SERVICE BULLETIN

SERVICE BULLETIN NO: 24-010

ELECTRICAL POWER - DC GENERATION REPLACEMENT OF GENERATOR 2

Replacement of the Generator 2 (P/N 524.32.12.147) with a new generator (P/N 524.32.12.158).

Generator 2 - Schematic - MSN 101 thru MSN 230 (Pre-SB 24-010)
Figure 6 (Sheet 1 of 4)

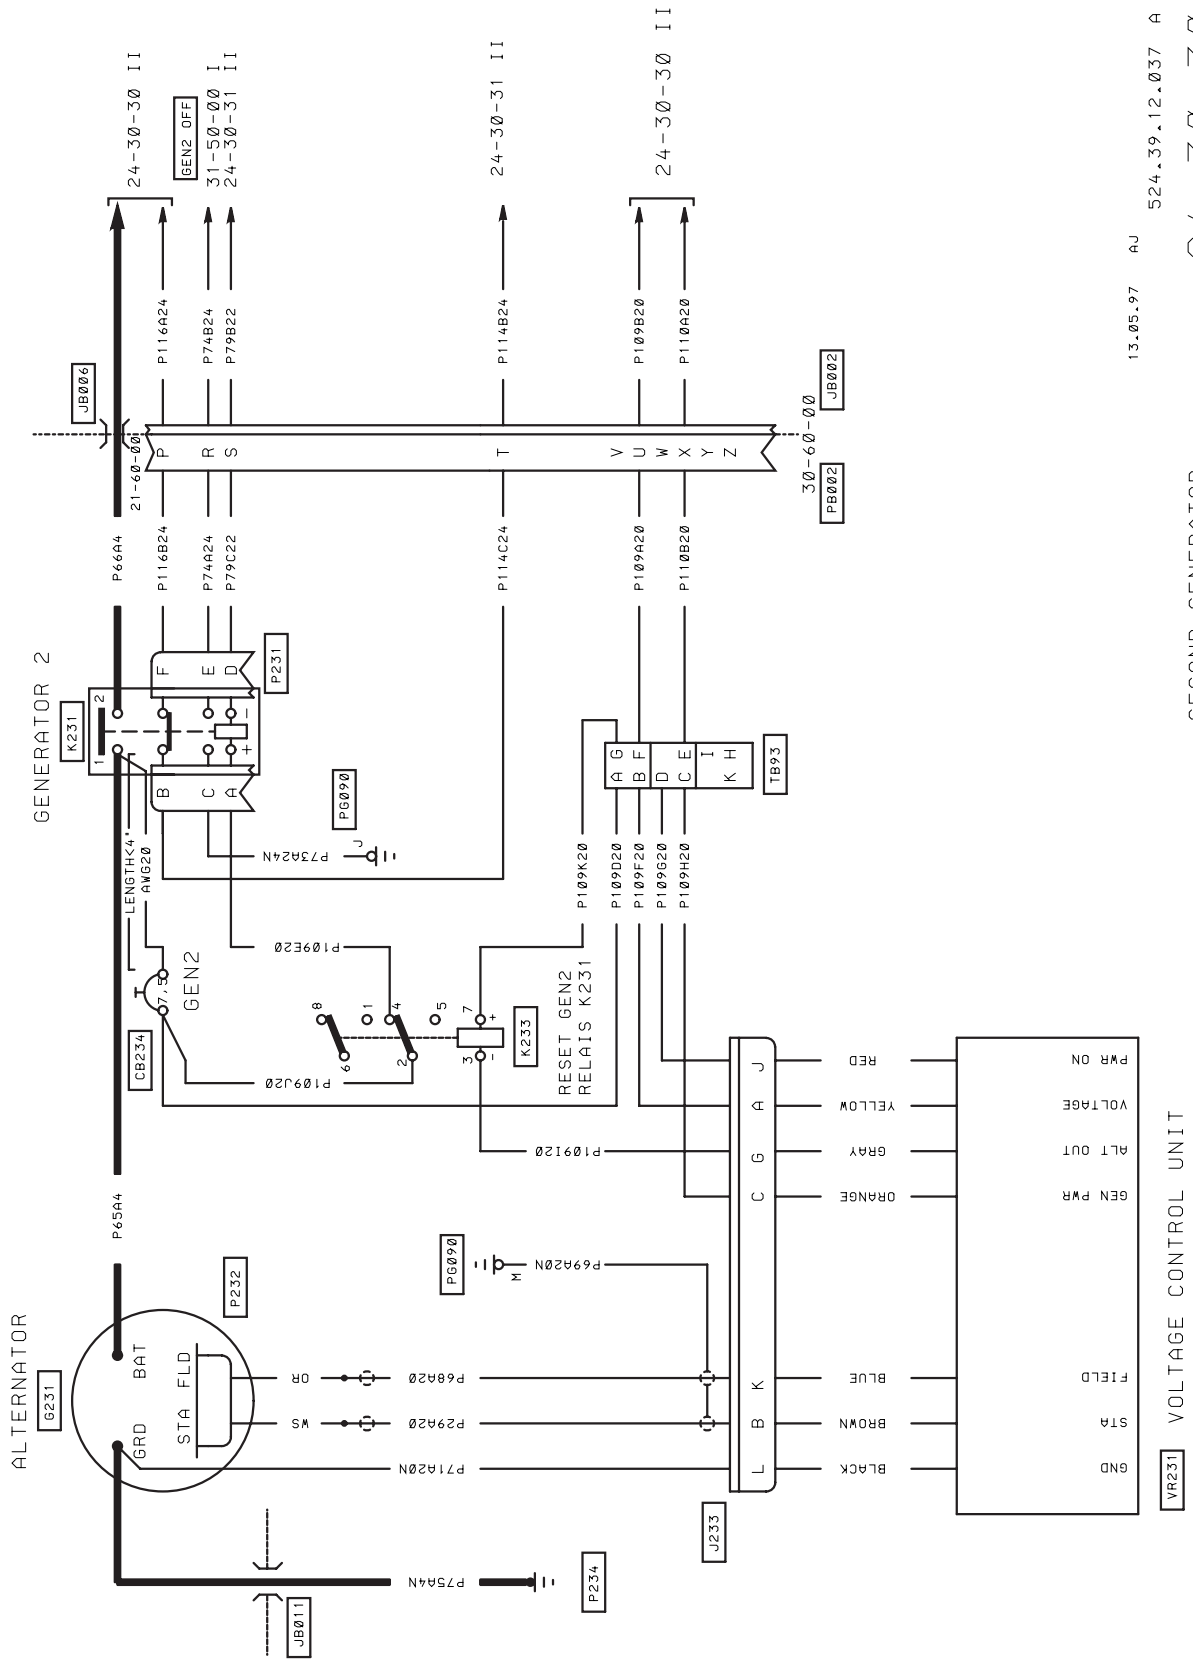
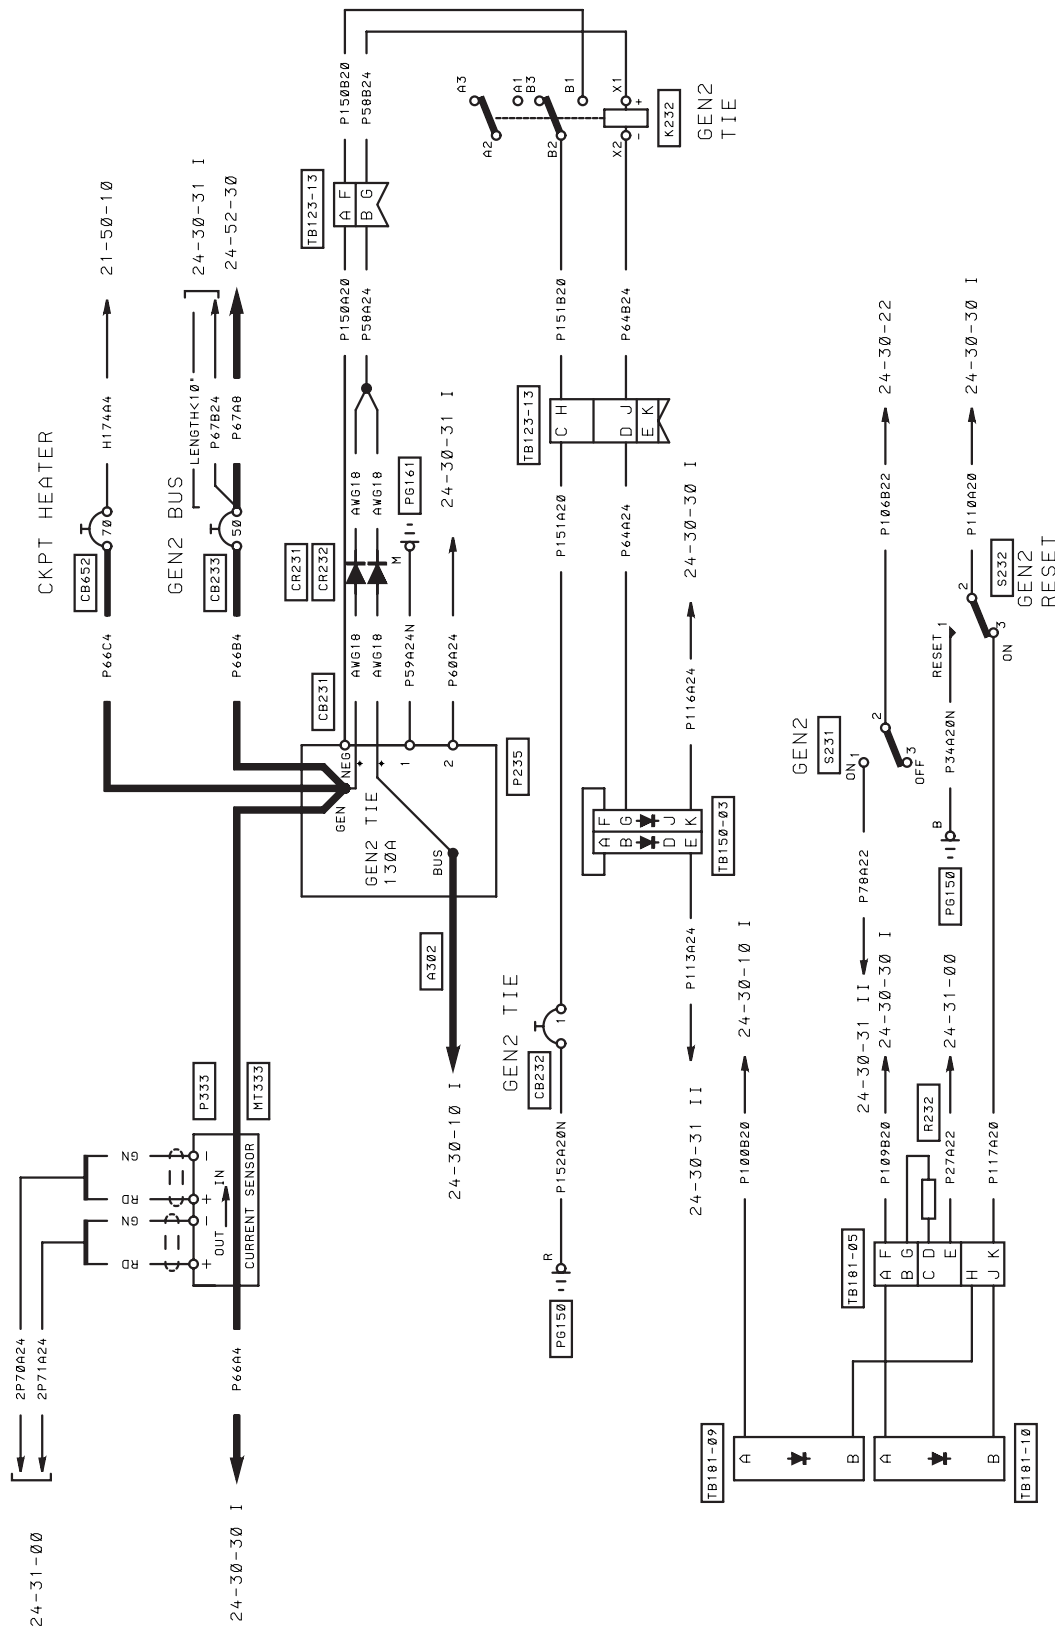
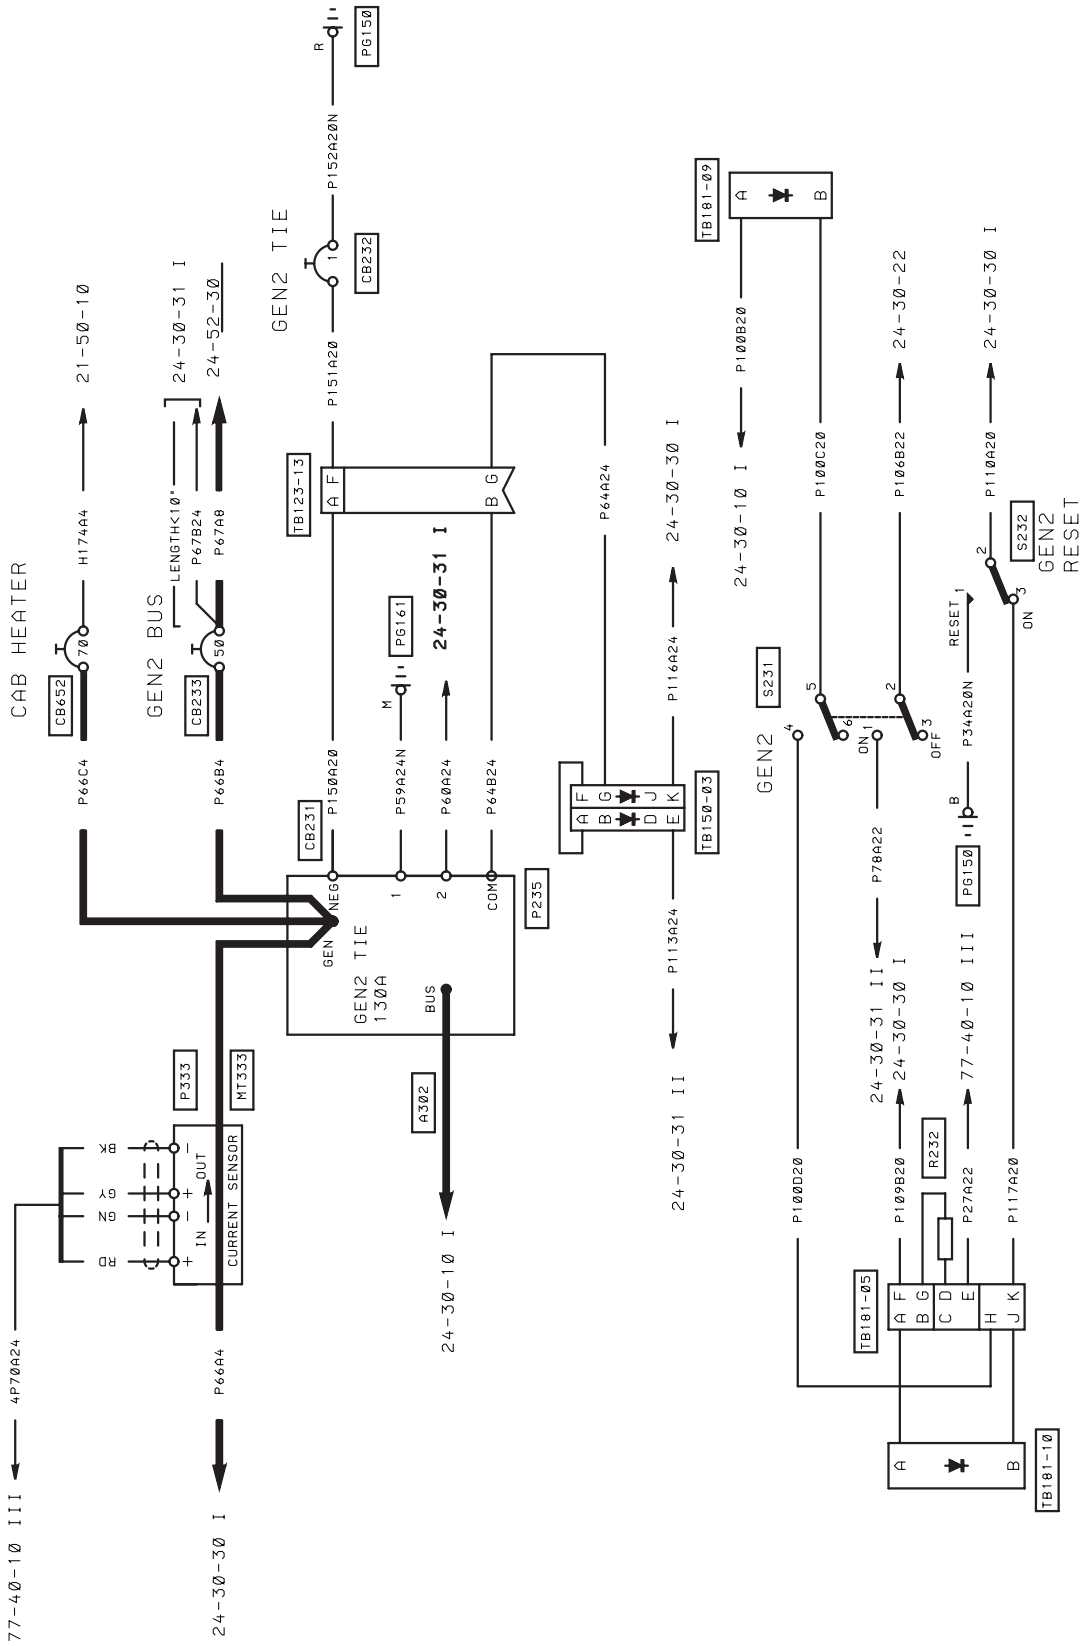
- (1) Disconnect the following cables and wires (Ref. Fig 6):
 - P75A4N from G231 (pin GRD)
 - P65A4 from G231 (pin BAT)
 - P71A20N from G231 (pin GRD)
 - P29A20 from P232 (pin STA)
 - P68A20 from P232 (pin FLD)
- (2) Remove and discard the drive belt from the Generator 2 (Ref. AMM, 24-30-03, Page Block 401).
- (3) Remove and discard the Generator 2 and the turn-buckle assembly (Ref. AMM, 24-30-02, Page Block 401).
- (4) Remove the starter/generator (Ref. AMM, 24-30-01, Page Block 401). Hold the starter/generator clear of the its drive shaft then remove and discard the O-ring seal.
- (5) Remove and disassemble the drive assembly (Ref. AMM, 24-30-04, Page Block 401). Discard the drive pulley and drive housing.

F. Wiring - Removal (Ref. Fig. 5, 6 and 7)

- (1) Remove the four screws (1) and overhead EPM panel (2) (Ref. Fig. 5).
- (2) Disconnect, and where necessary, remove the wires (Ref. Table, Wire/Cable - Removal and Fig. 6).

Wire	Terminal/Connector	Terminal/Connector	Remarks
N/A	Wire from R232	TB181-05, Pin G	Disconnect from TB181-05
N/A	Wire from TB181-10/A	TB181-05, Pin A	Disconnect from TB181-05
N/A	Wire from TB181-10/B	TB181-05, Pin J	Disconnect from TB181-05
P100C20	S231, Pin 5	TB181-09, Pin B	Remove and discard (MSN 181 thru MSN 230)
P100D20	S231, Pin 4	TB181-05, Pin H	Remove and discard (MSN 181 thru MSN 230)

Wire	Terminal/Connector	Terminal/Connector	Remarks
P109A20	PB002, Pin U	TB093-01, Pin F	Remove and discard
P109B20	TB181-05, Pin F	JB002, Pin U	Remove and discard
P109D20	TB093-01, Pin A	CB234	Remove and discard
P109E20	K231, Pin A	K233, Pin 4	Remove and discard
P109F20	TB93, Pin B	J233, Pin A	Remove and discard
P109G20	TB93, Pin D	J233, Pin J	Remove and discard
P109H20	TB093-01, Pin C	J233, Pin C	Remove and discard
P109I20	K233, Pin 3	J233, Pin G	Remove and discard
P109J20	K233, Pin 2	CB234	Remove and discard
P109K20	TB093-01, Pin G	K233, Pin 7	Remove and discard
P110A20	S232, Pin 2	N/A	Disconnect at specified end
P110B20	TB093-01, Pin E	N/A	Disconnect at specified end
P117A20	TB181-05, Pin K	N/A	Disconnect at specified end
P117A20	S232, Pin 3	N/A	Disconnect at specified end
P34A20N	S232, Pin 1	N/A	Disconnect at specified end
P78A22	S231, Pin 1	N/A	Disconnect at specified end

Generator 2 - Schematic (Sheet 1) (Post SB 24-010)
Figure 7 (Sheet 1 of 2)

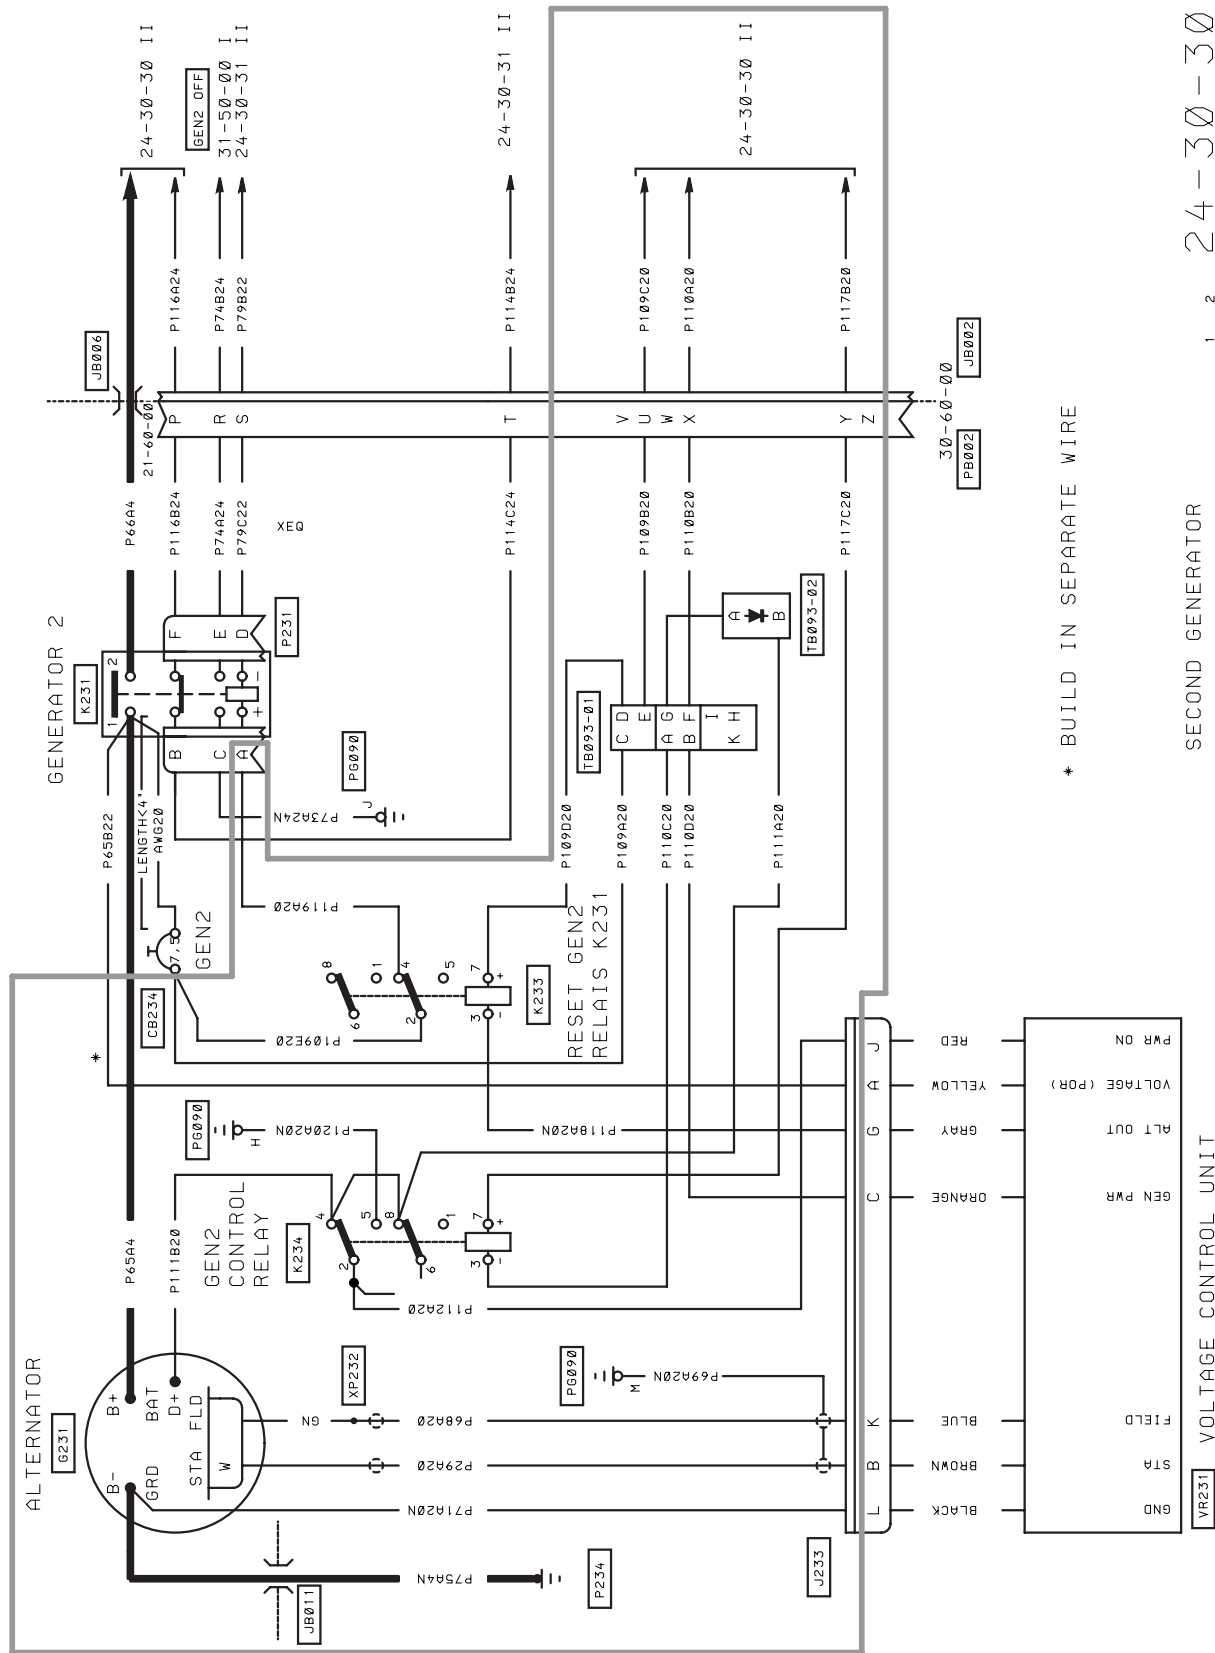
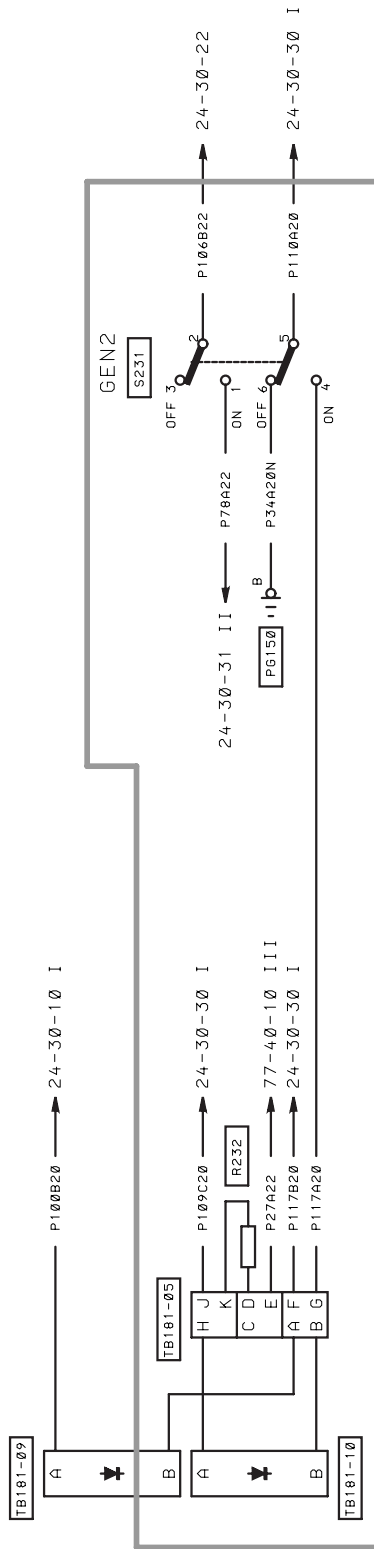
H. Wiring - Installation (Ref. Figs. 3, 5, 6, 7 and 8)

- (1) Put the applicable wires in their correct routing positions and connect as necessary (Ref. Table, Wire/Cable - Installation and Fig. 6).

Component From & Ident		End Connector	Wire/Cable	End Connector	Component To & Terminal Ident		Remarks
N/A	N/A	N/A	N/A		B	TB093-02	Install reducer
N/A	N/A	N/A	N/A		A	TB093-02	Install reducer
N/A	N/A	N/A	R232	N/A	K	TB181-05	No wire ident
TB181-10	B	N/A	N/A	N/A	B	TB181-05	No wire ident
TB181-10	A	N/A	N/A	N/A	H	TB181-05	No wire ident
CB234	-	-	P109A20	971.42.31.536	C	TB093-01	
PB002	U	971.75.18.913	P109B20	971.42.31.536	E	TB093-01	
JB002	U	971.75.18.903	P109C20	971.42.31.536	J	TB181-05	
K233	7	971.75.16.927	P109D20	971.42.31.536	D	TB093-01	
CB234	-	-	P109E20	971.75.16.927	2	K233	
JB002	X	N/A	P110A20	972.55.38.499	5	S231	
PB002	X	N/A	P110B20	971.42.31.536	F	TB093-01	
K234	3	971.75.16.927	P110C20	971.42.31.536	A	TB093-01	
J233	C	971.75.16.821	P110D20	971.42.31.536	B	TB093-01	
K234	8	971.75.16.927	P111A20	971.42.31.537	B	TB093-02	
K234	4	971.75.16.927	P111B20	971.31.18.820	D+	GEN2	Install lug
TB181-05	G	971.42.31.536	P117A20	972.55.38.499	4	S231

JB002	Y	971.75.18.903	P117B20	971.42.31.536	F	TB181-05	
PB002	Y	971.75.18.913	P117C20	971.75.16.927	7	K234	
J233	G	971.75.16.821	P118A20N	971.75.16.927	3	K233	Ground wire
K233	4	971.75.16.927	P119A20	971.75.16.822	A	P231	
N/A	N/A	N/A	P29A20	971.31.18.830	W	GEN2	Install lug STA
N/A	N/A	N/A	P34A20N	972.55.38.499	6	S231

Component From & Ident		End Connector	Wire/Cable	End Connector	Component To & Terminal Ident		Remarks
N/A	N/A	N/A	P65A4	971.31.18.526	B+	GEN2	Install lug (yellow) BAT
J233	A	971.75.16.821	P65B22	971.31.18.830	1	K231	
N/A	N/A	N/A	P68A20	971.31.18.820	DR	XP232	FLD XP232
N/A	N/A	N/A	P71A20N	971.31.18.573	B-	GEN2	Install lug (red) GRD
N/A	N/A	N/A	P75A4N	971.31.18.527	B-	GEN2	Install lug (yellow) GRD
N/A	N/A	N/A	P78A22	972.55.38.499	3	S231	Ident 4
K234	8	971.75.16.927	AWG20	971.75.16.927	4	K234	Bridging wire
K234 Link J233	2 J	971.75.16.927 No Terminal 971.75.16.819	AWG20 AWG20 P112A20	971.31.32.637		Splice	Blue (Ref. Fig 7)
K234	6	971.75.16.927	AWG20	No Terminal			
TB093-01	G	971.42.31.536	AWG20	971.42.31.537	A	TB093-02	Bridging wire
TB181-09	B	971.42.31.536	AWG20	971.42.31.536	A	TB181-05
